GENERAL ELECTRIC

May 30, 1985

Reference: Certificate of Compliance No. 5942, Docket No. 5942.

GENERAL ELECTRIC SHIELDED CONTAINER - MODEL 700

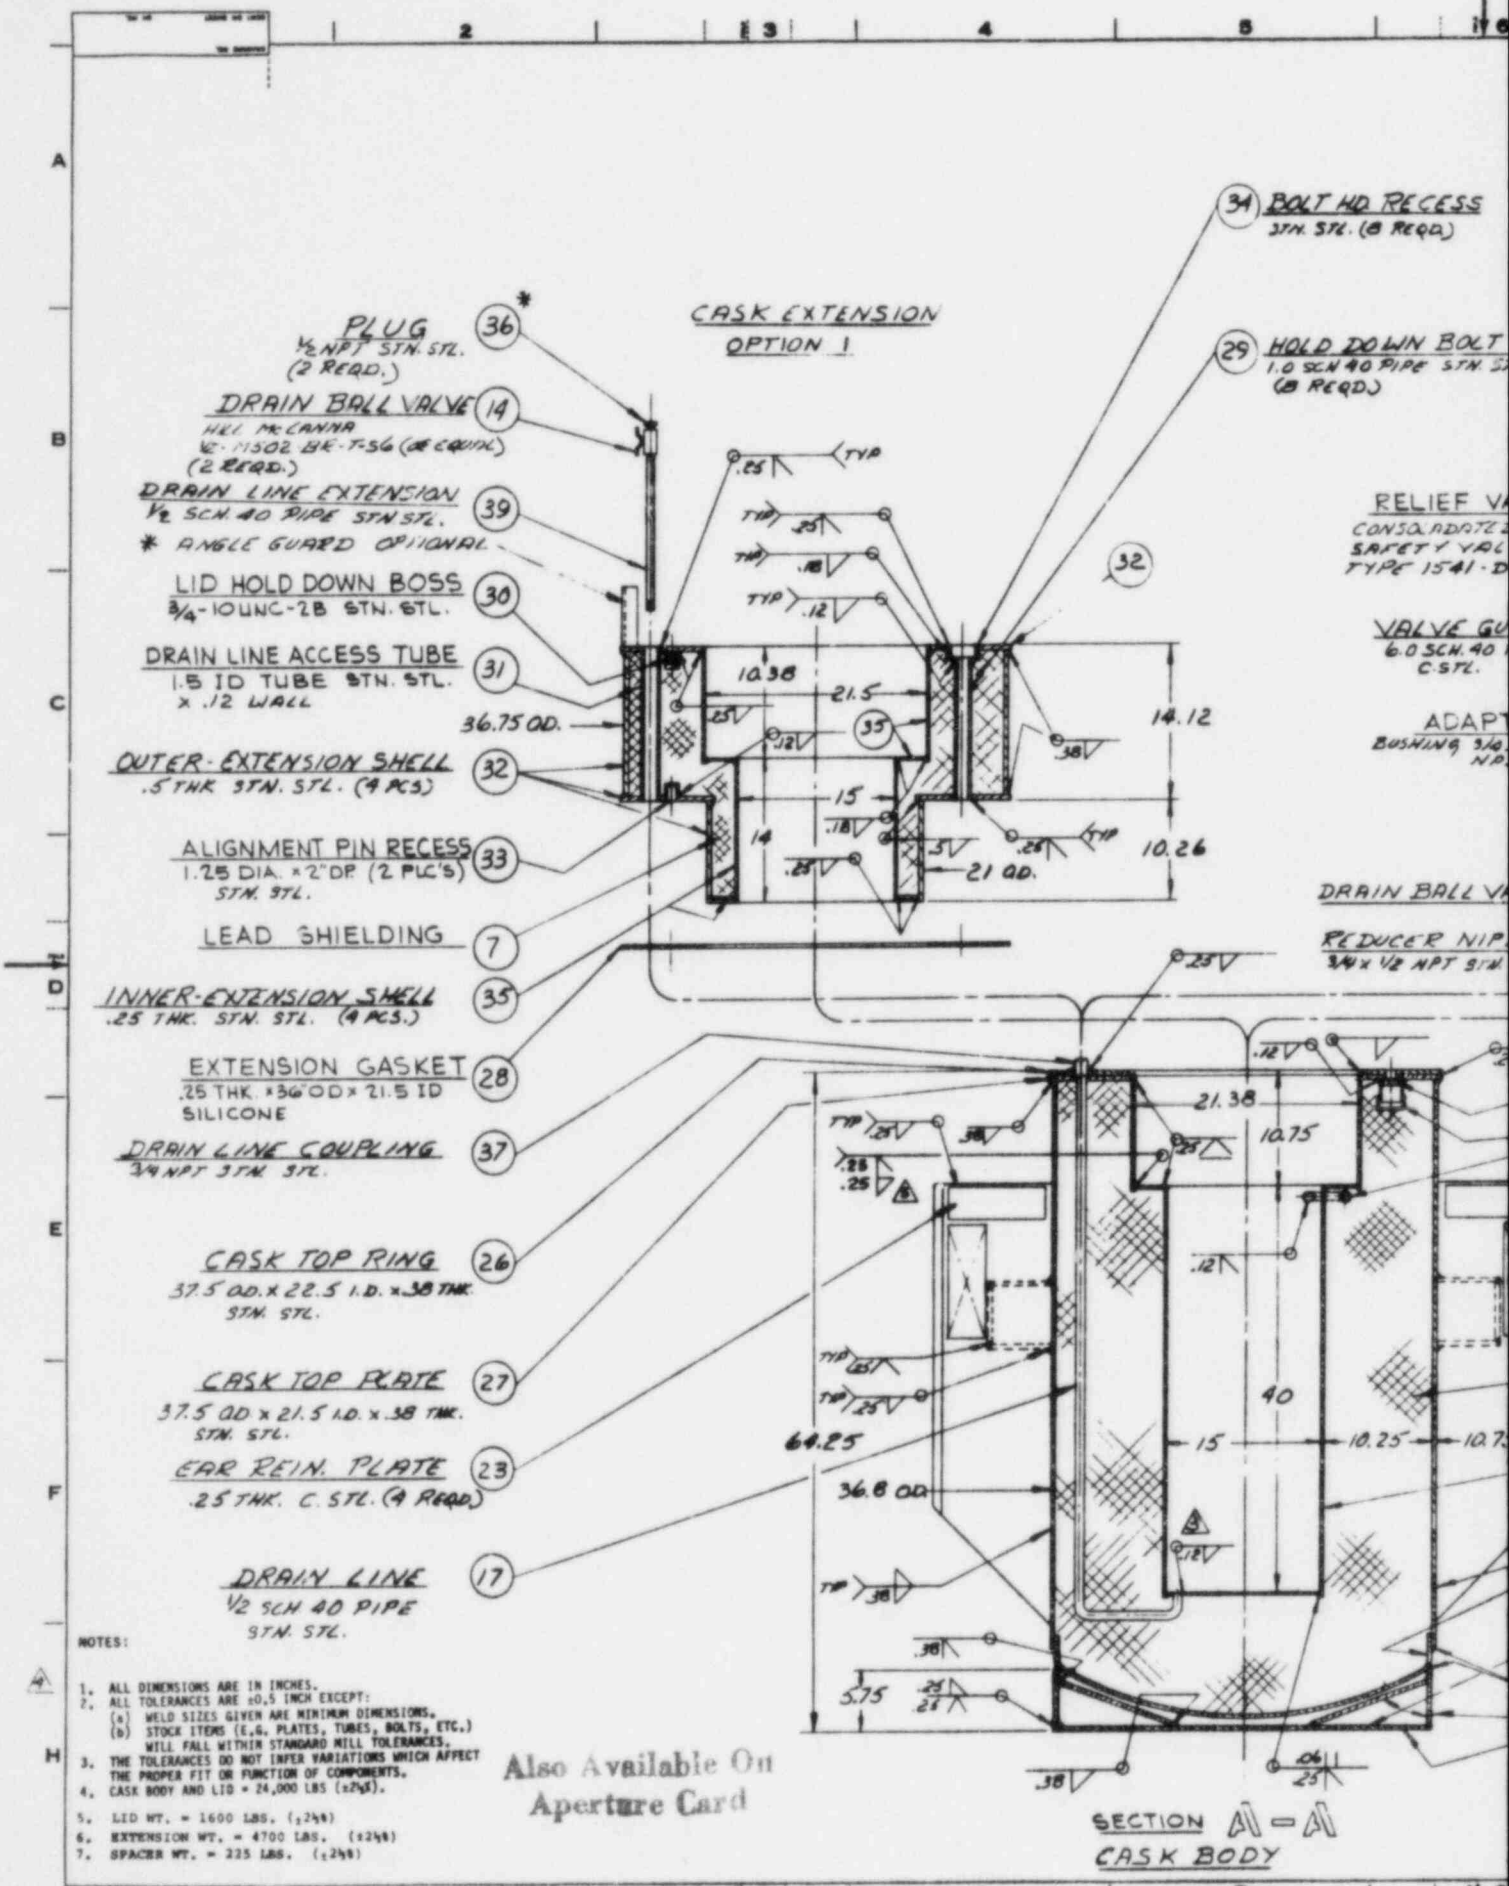
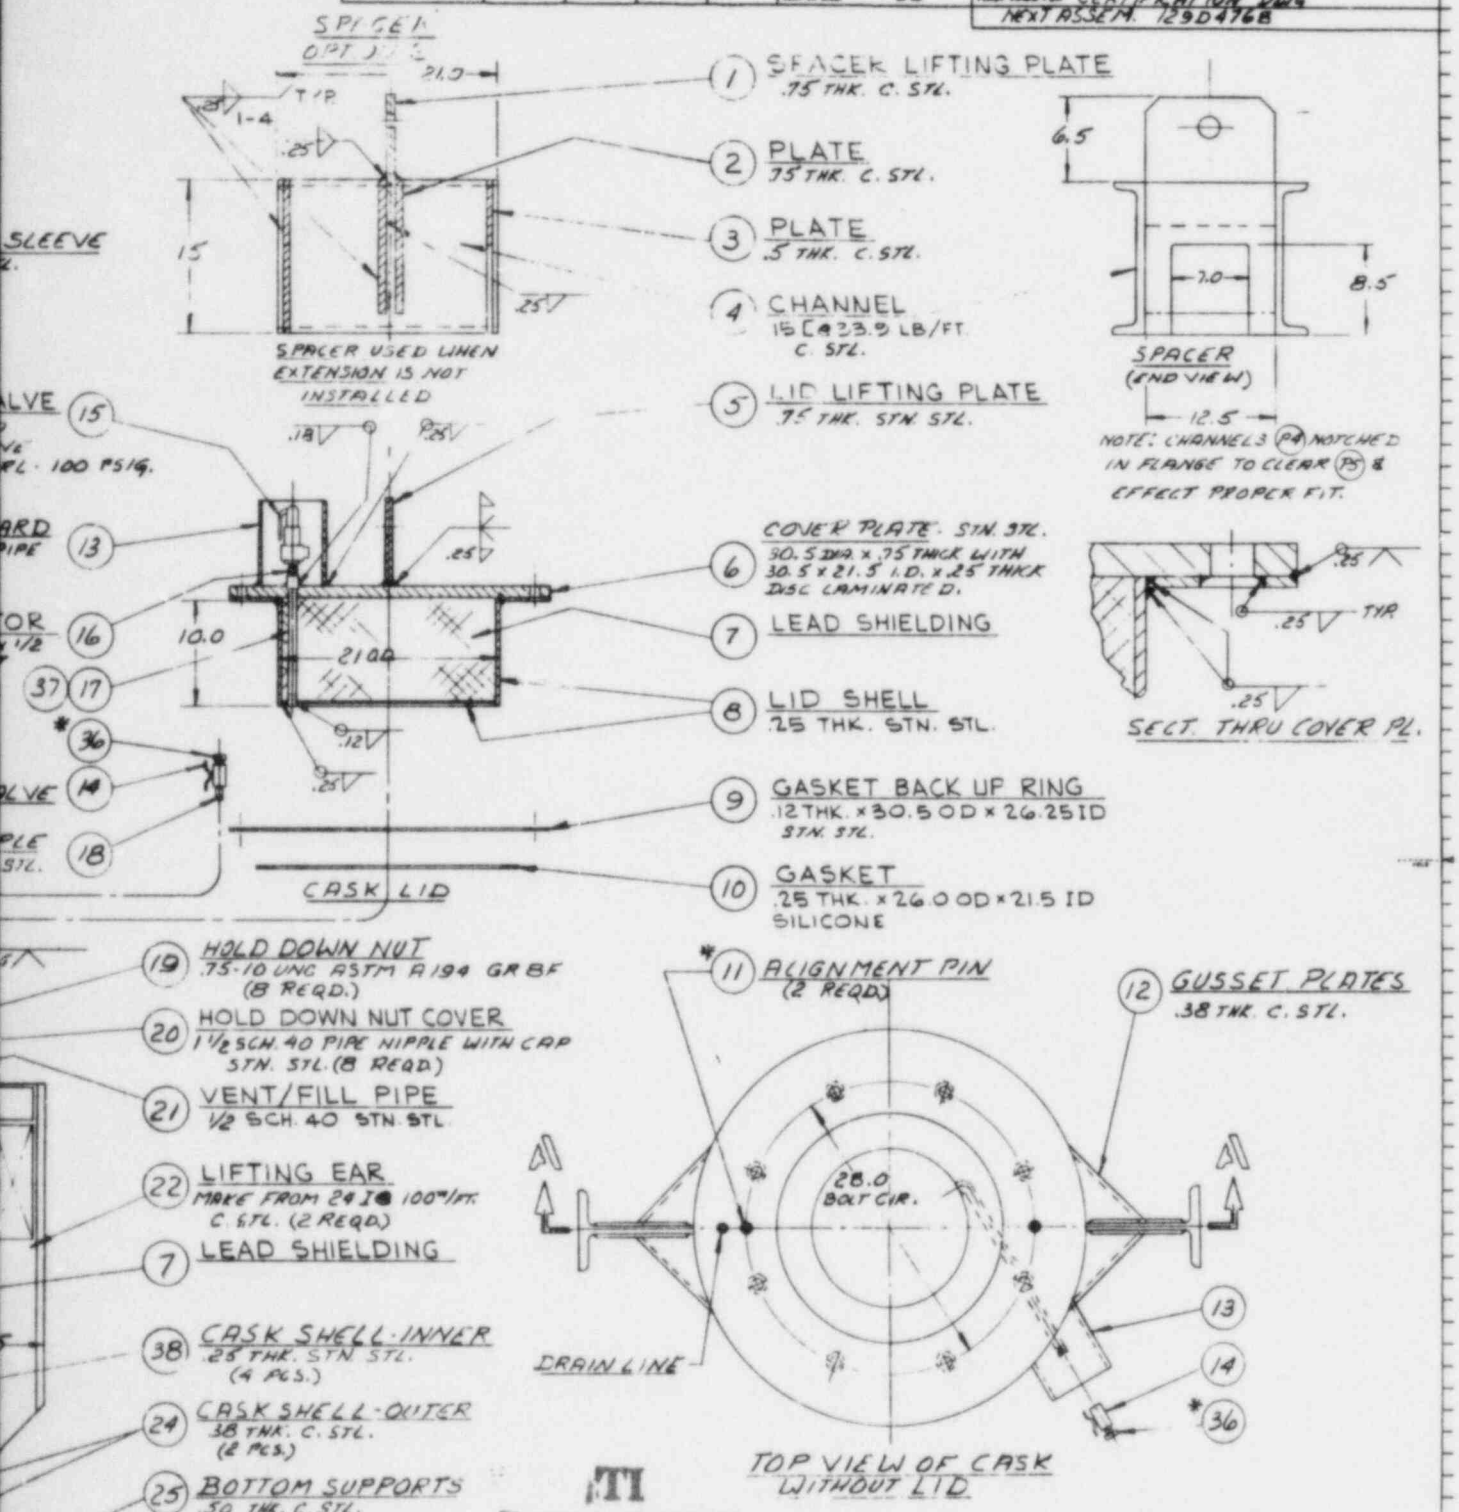
In addition, one of the certification drawings (129D4770) has been revised to show an added fillet weld on the cavity step (Zone E-4) to reinforce the weld joint.
